from
**Southern
Water**

Our ref
PLAN-029636

Proposal: 1 No. dwelling & associated works.

Site: BN/75/19/PL: - Land adjacent to Cherry Trees, Lake Lane, Barnham, PO22 0AD.

ARUN DISTRICT COUNCIL BN/75/19/PL

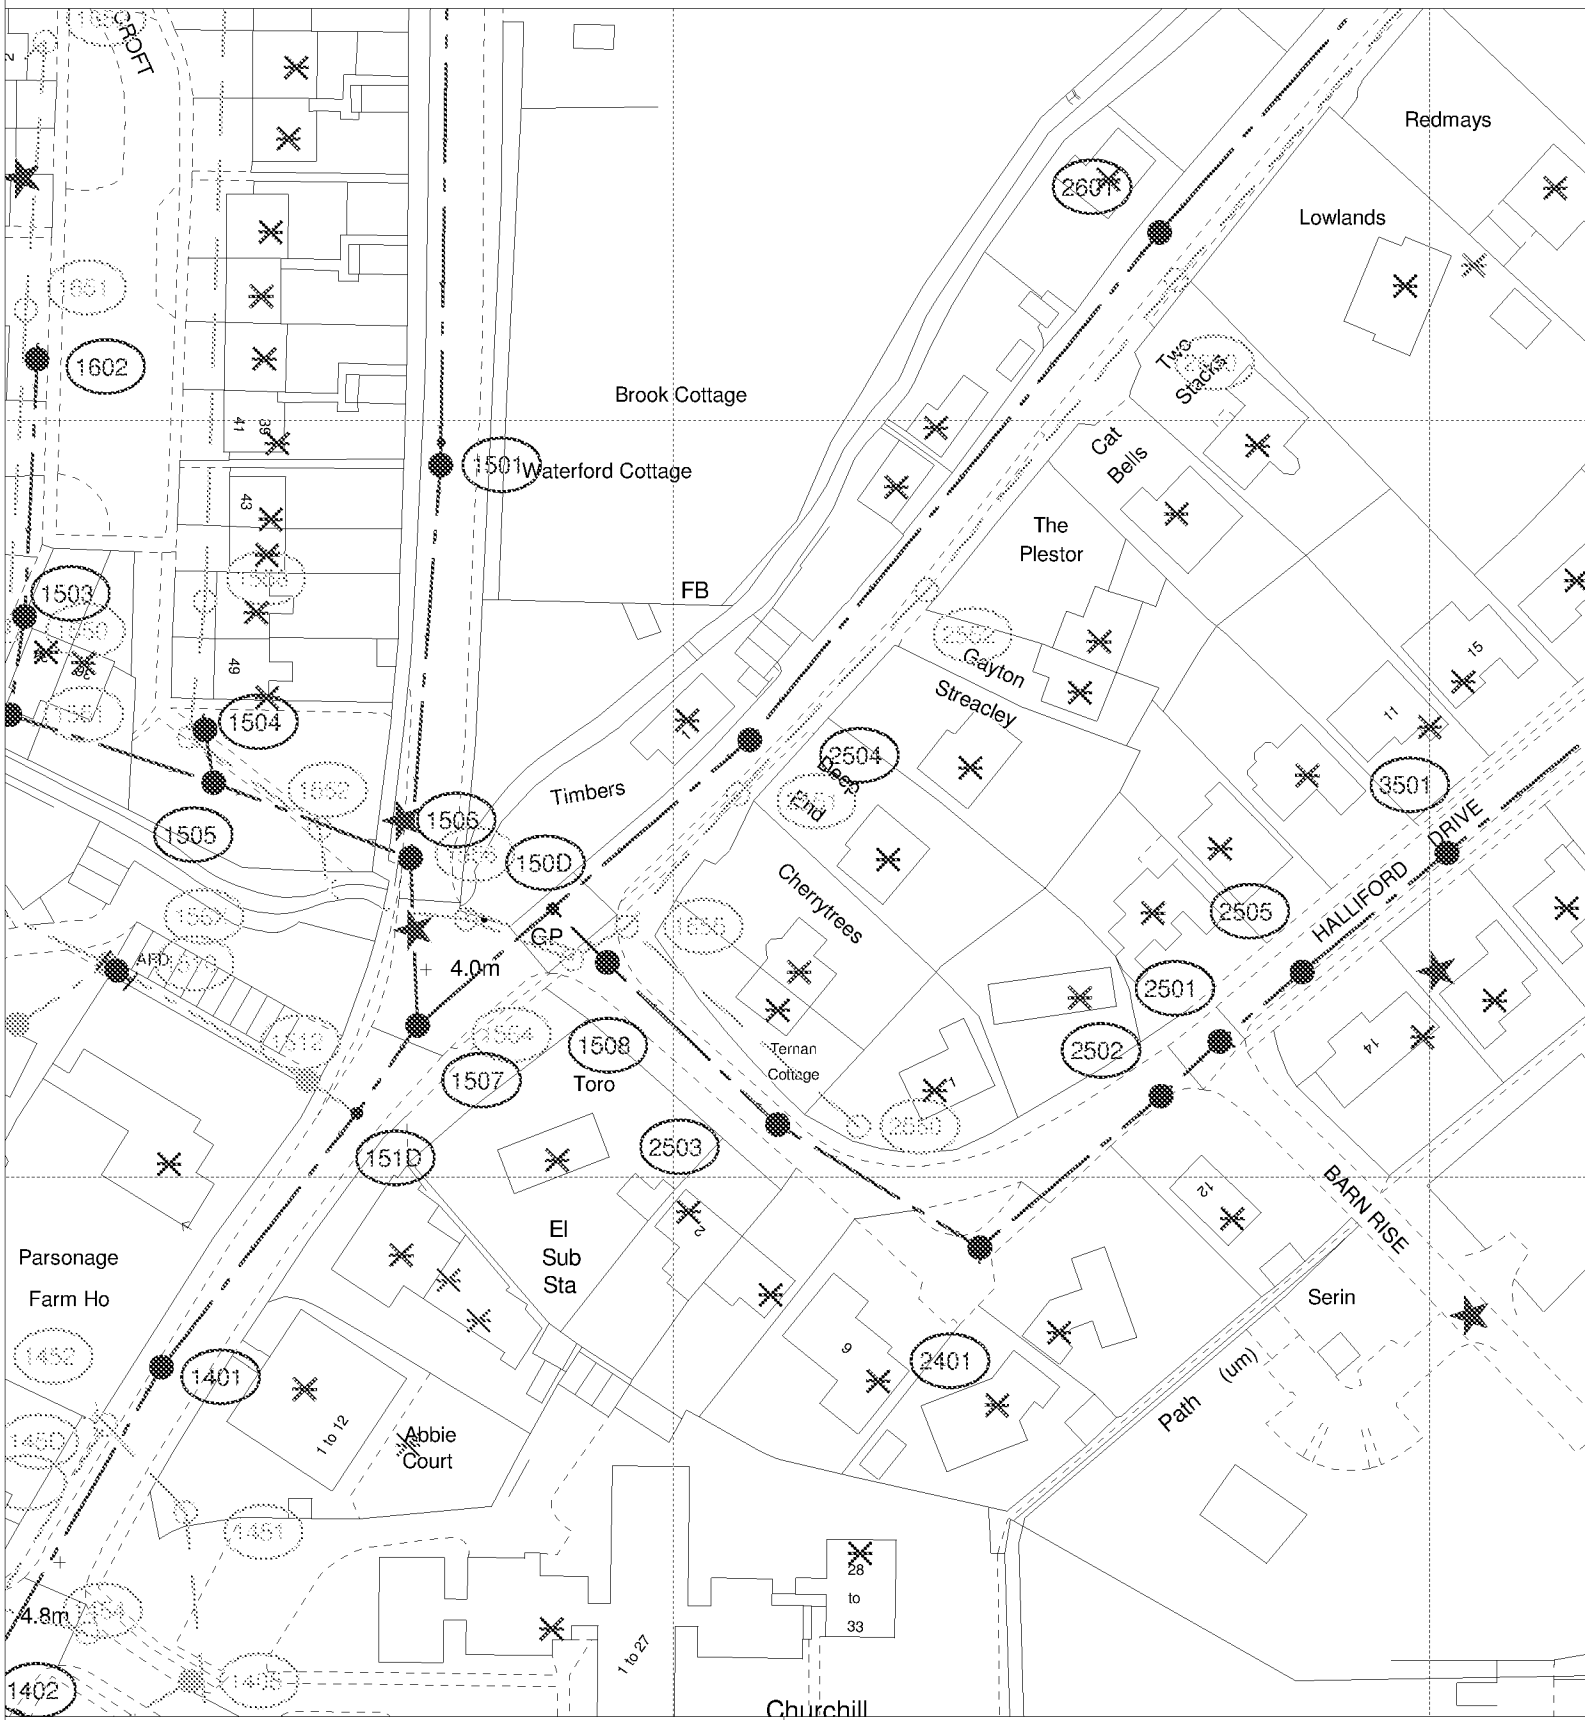
It is possible that a sewer now deemed to be public could be crossing the development site. Therefore, should any sewer be found during construction works, an investigation of the sewer will be required to ascertain its ownership before any further works commence on site.
